Access Compliance Report Public Rights-of-Way (Curb Ramps)

Main Street: CHESNEY_DR Cross Street: LOCH_LOMOND_RD Location: NE

ADA ID: RPAT211201084637 Ramp Type: Type 1 - Perpendicular Diagonal Initial Pass/Fail: Fail Overall Compliance: No Severity Score: 16

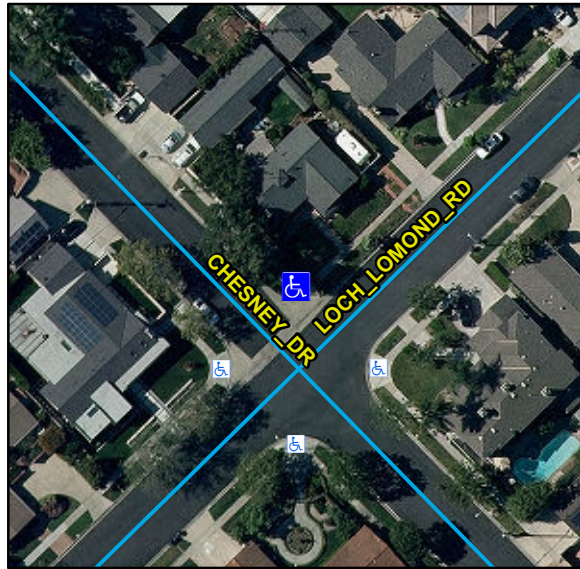
R304.2.2, R204.3, R304.5.3, STD 1115

Remove & Replace Curb Ramp With Two New Directional Ramps or Equivalent.
